MEMORANDUM

FILE NO.: CSP2012 0017
CSP2012 0018

PROPOSAL: Glacier Hwy and Mendenhall Loop Intersection safety improvements – Auke Bay Roundabout and a request for a perpetual easement across CBJ land to access a private residence.

PROJECT DESIGNATION	
69003	
STATE	YEAR
ALASKA	2012
SHEET NUMBER	TOTAL SHEETS
H4	XX

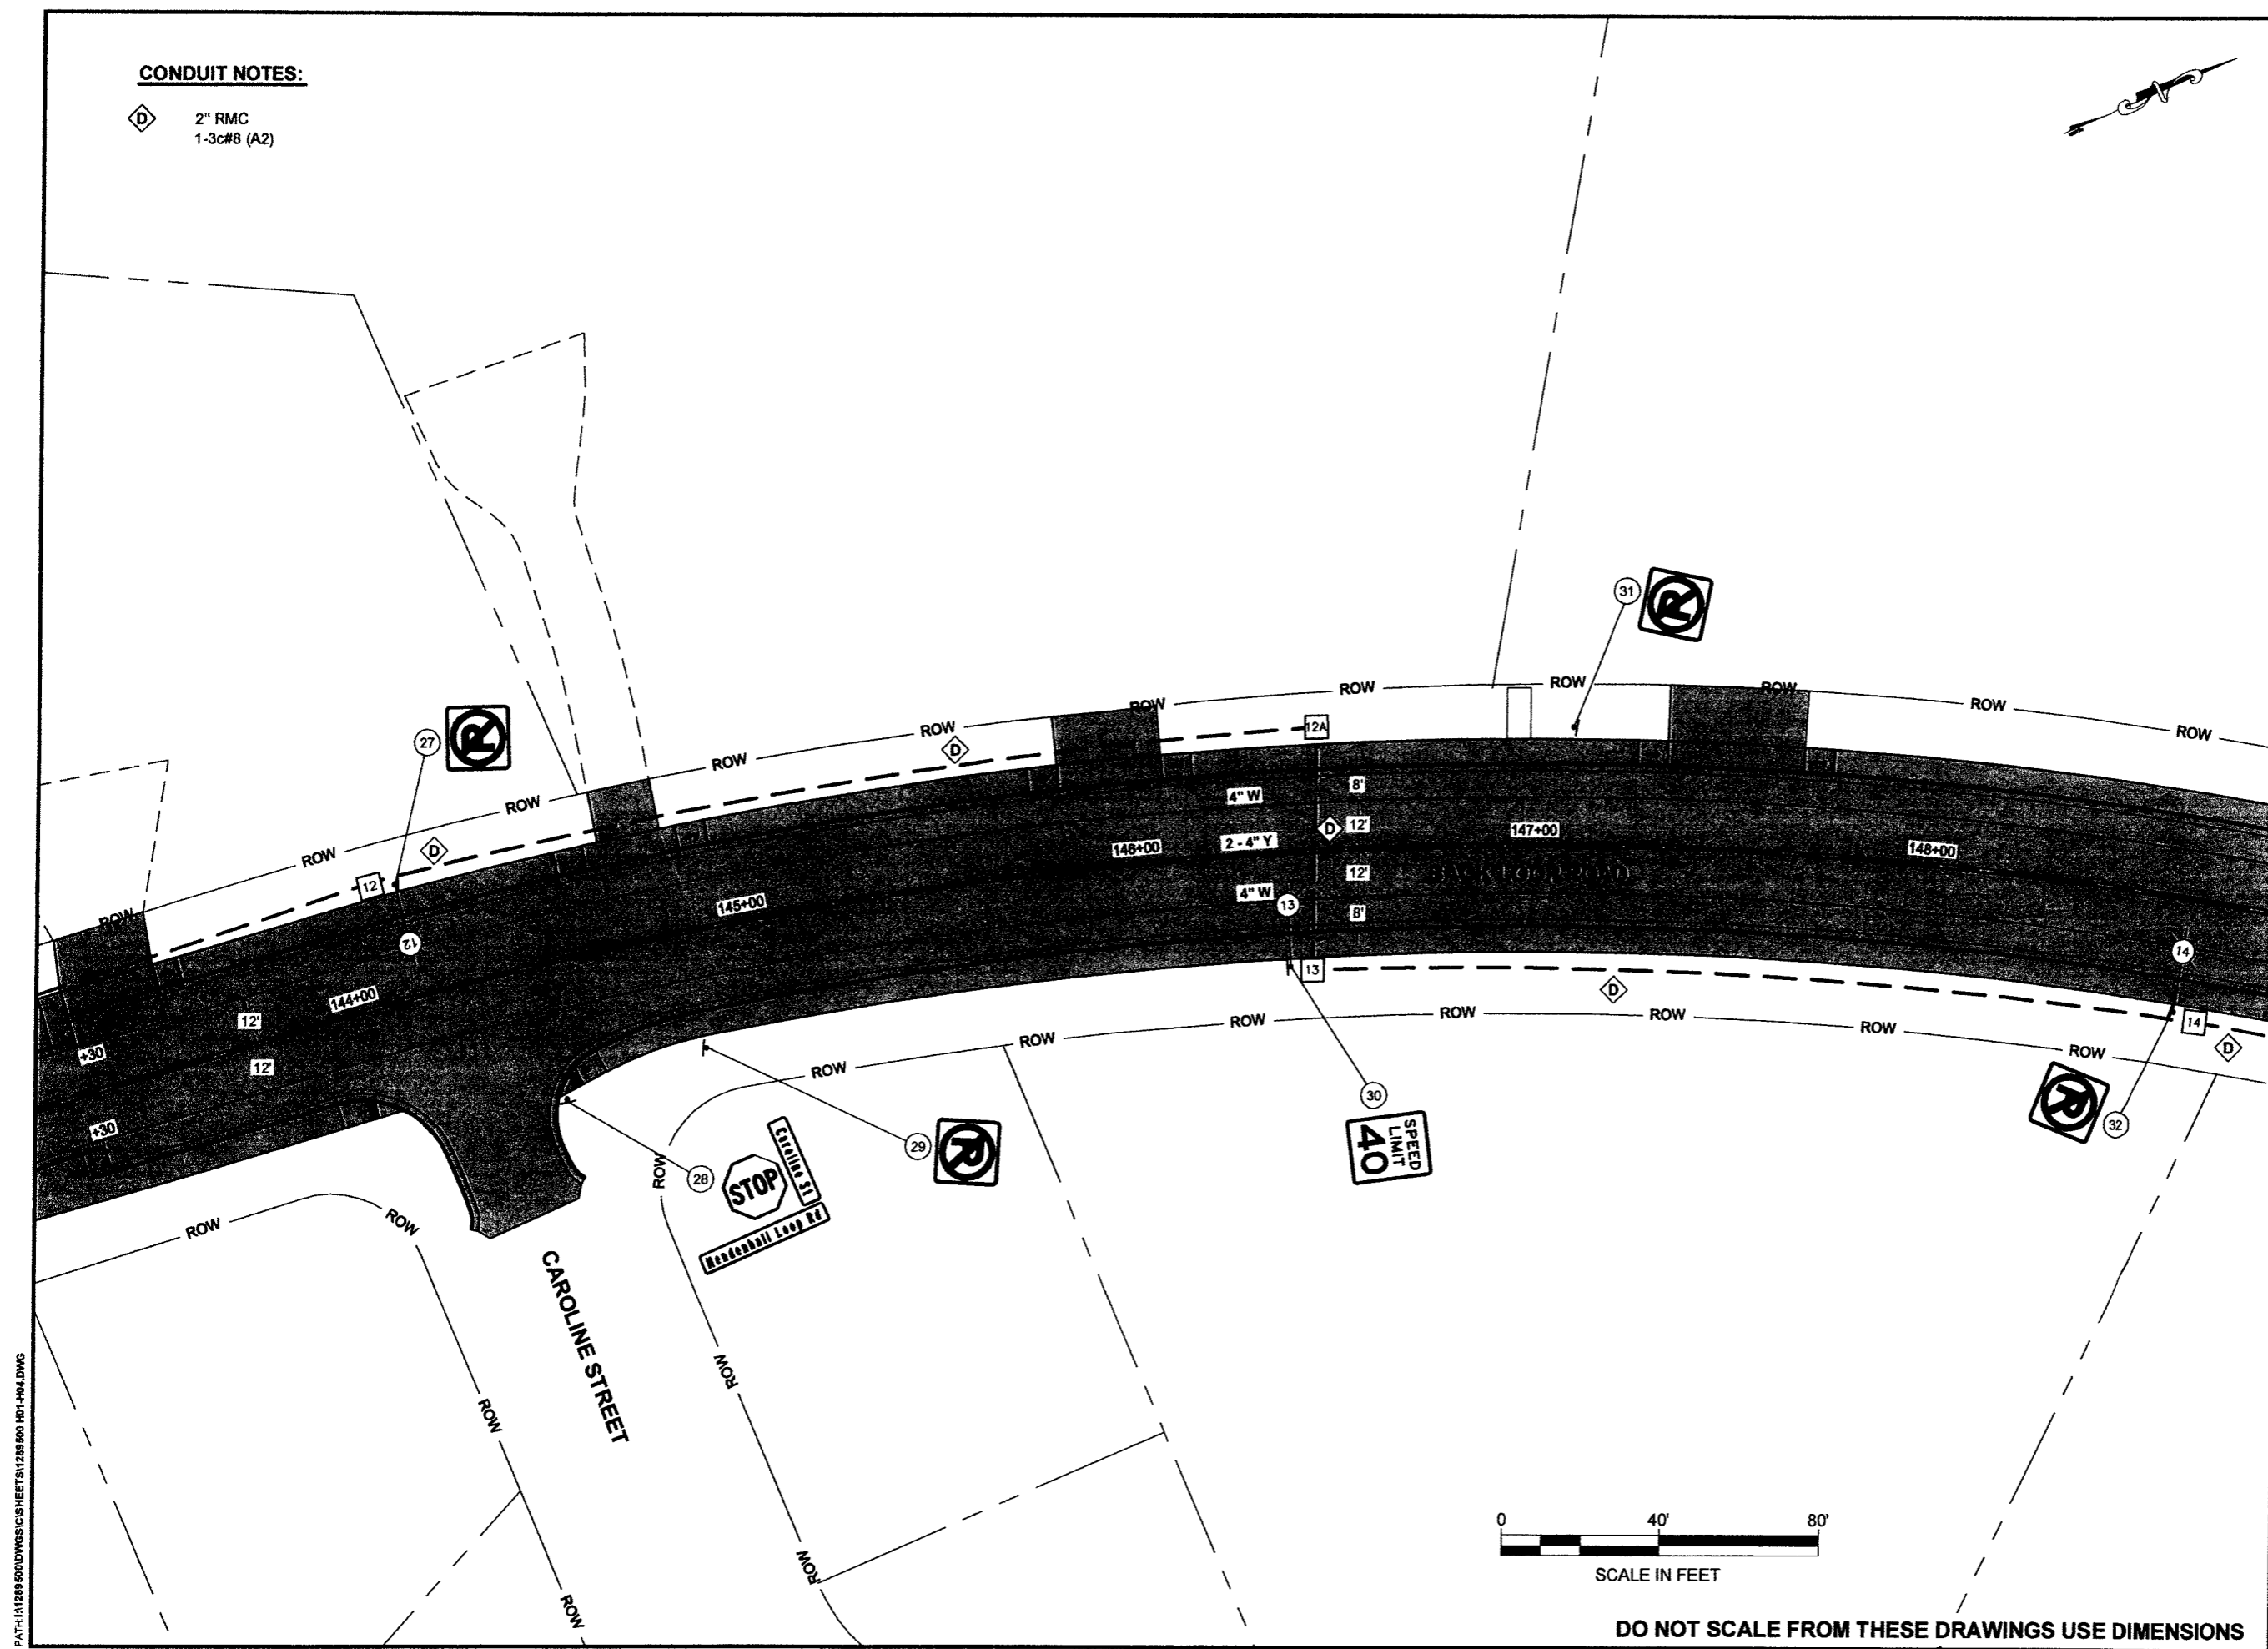
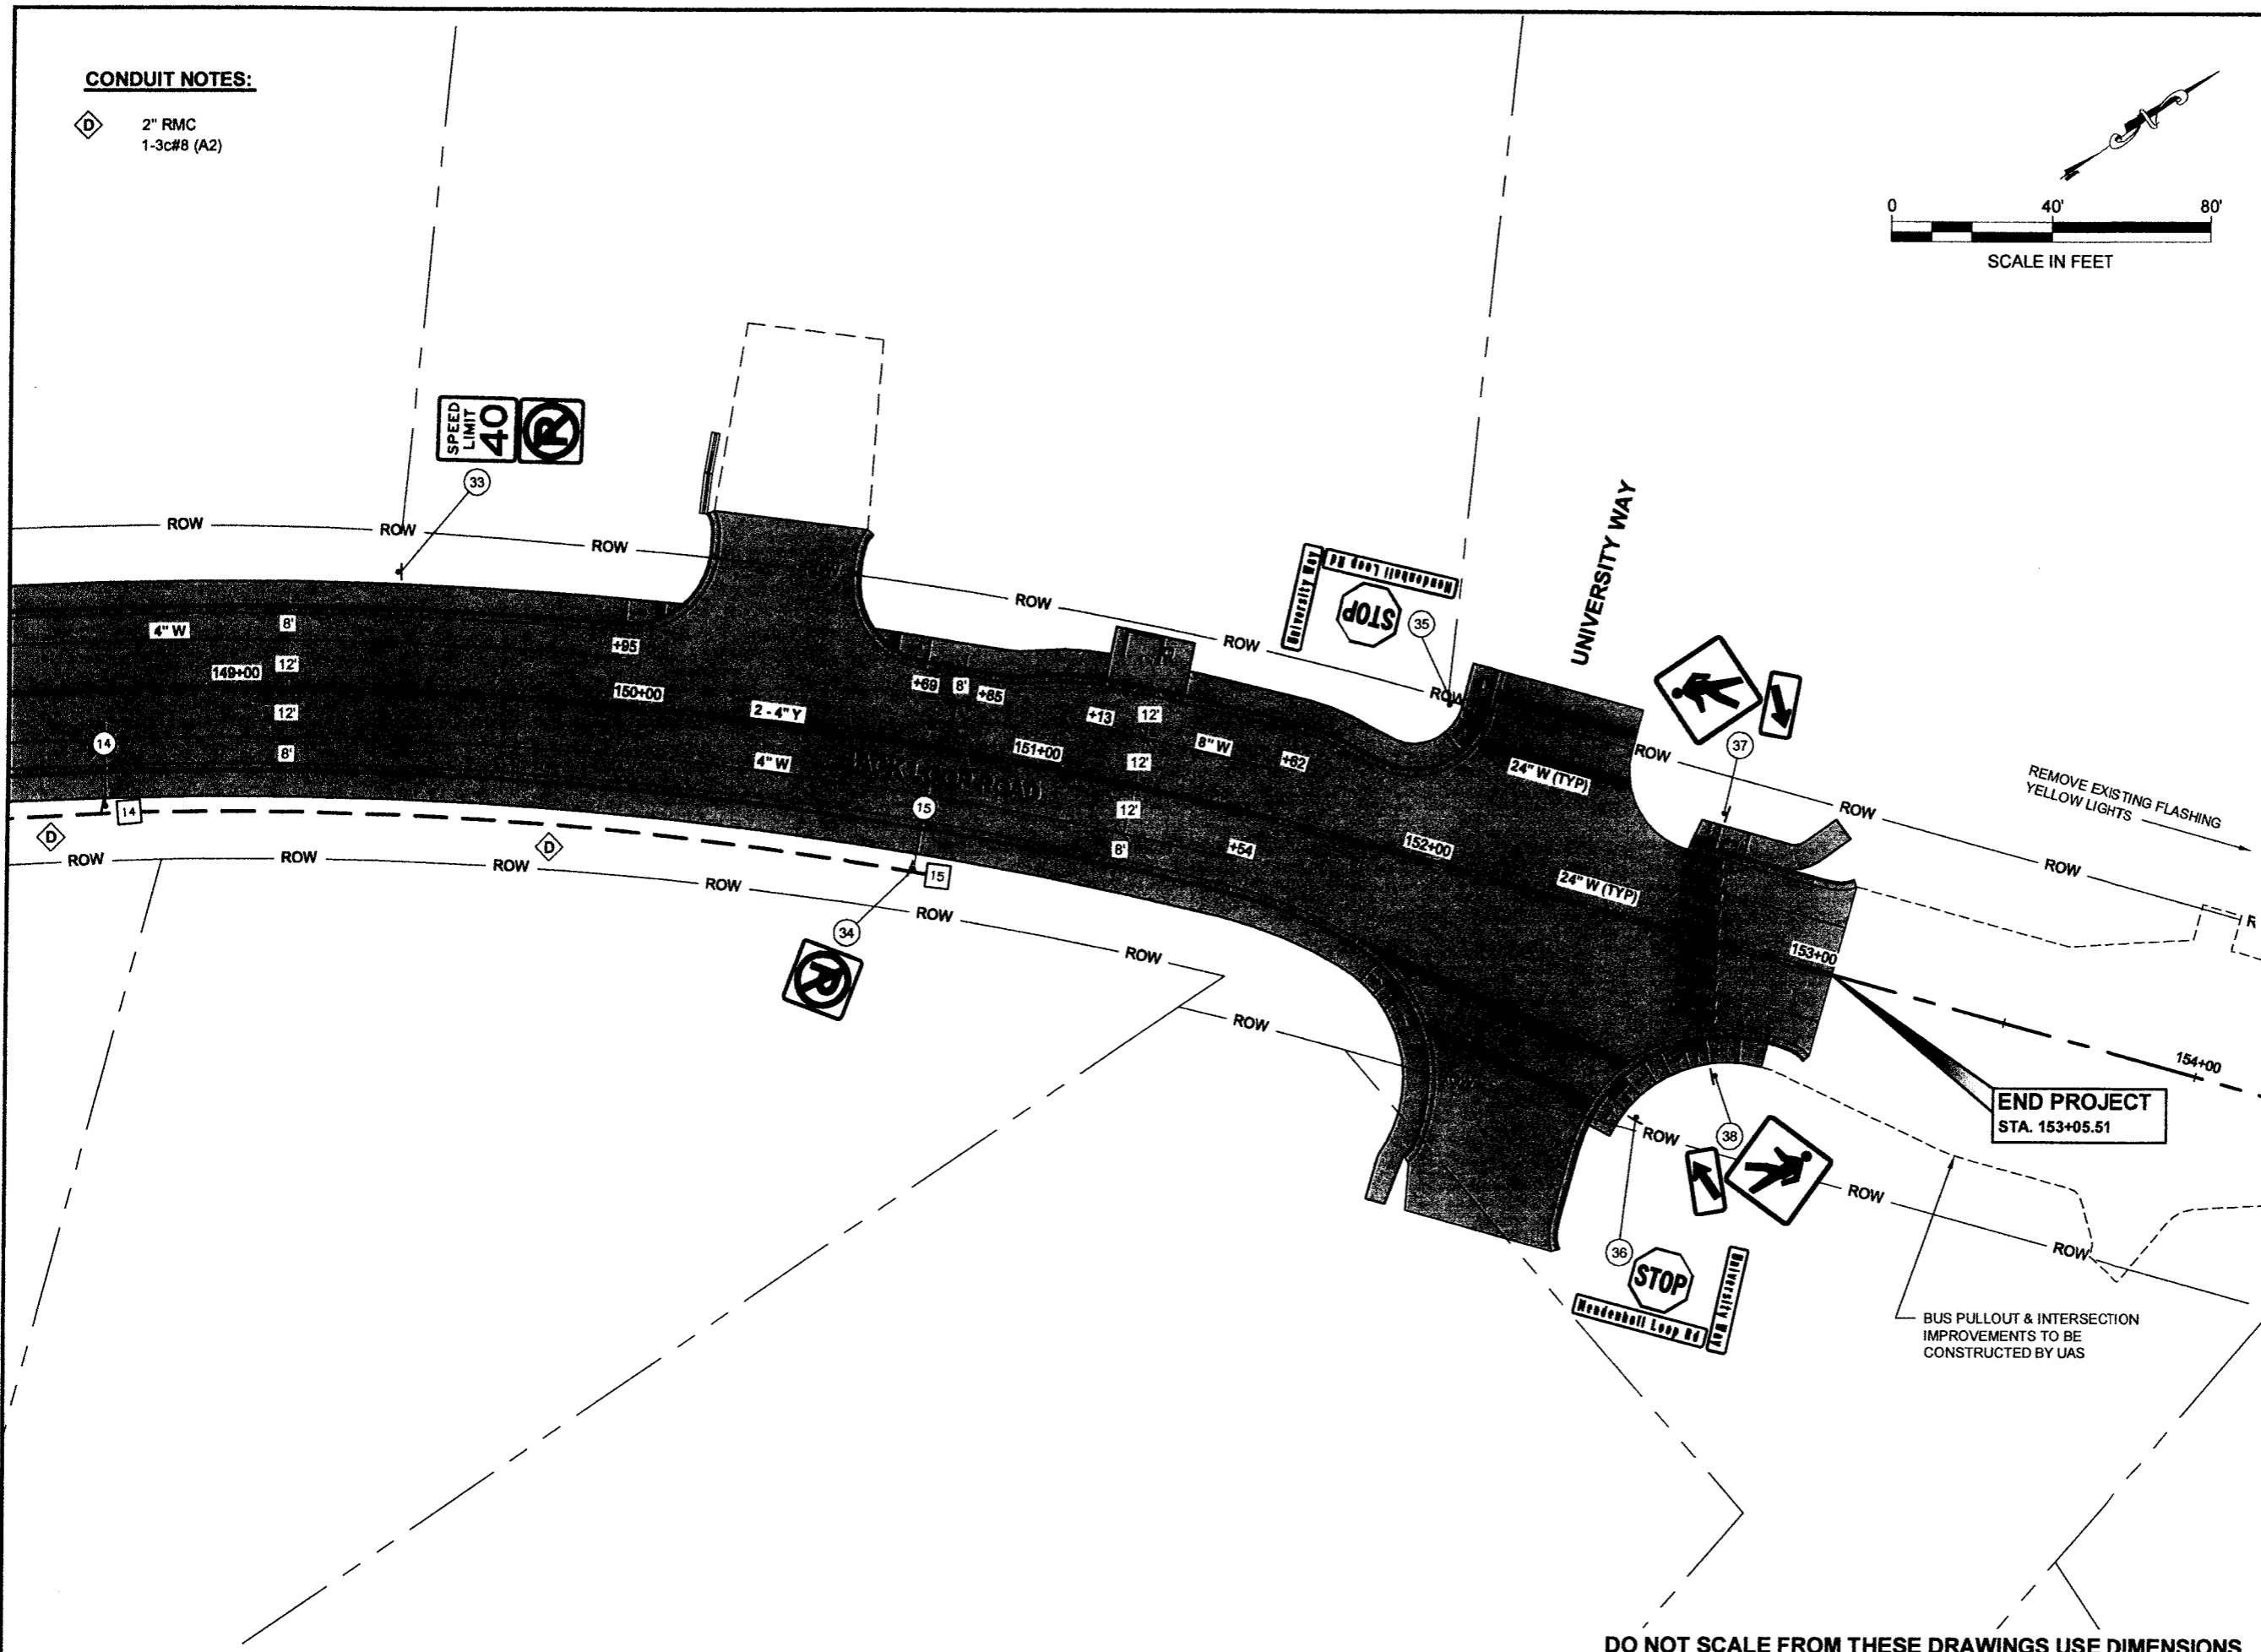
Bus shelters/stops: The existing bus shelter at the IPEC driveway will be relocated up the hill on the south side of the University Way intersection. See Sheet H4 Station 151+00. UAS has indicated that they will be building paved bus pullout and shelter on the north side of the University Way intersection.

Looking quickly at the plans it appears that DOT has eliminated the two harbor stops (inbound and outbound) and is relocating the current Harbor Bus shelter up to the University Entrance. I don't see any new or Temporary stops shown on the plans to replace the Harbor intersection stops. I am concerned that DOT has no intentions of constructing new bus stops to accommodate the Harbor area Transit users and intend to make them walk all the way up the hill to the University stops.
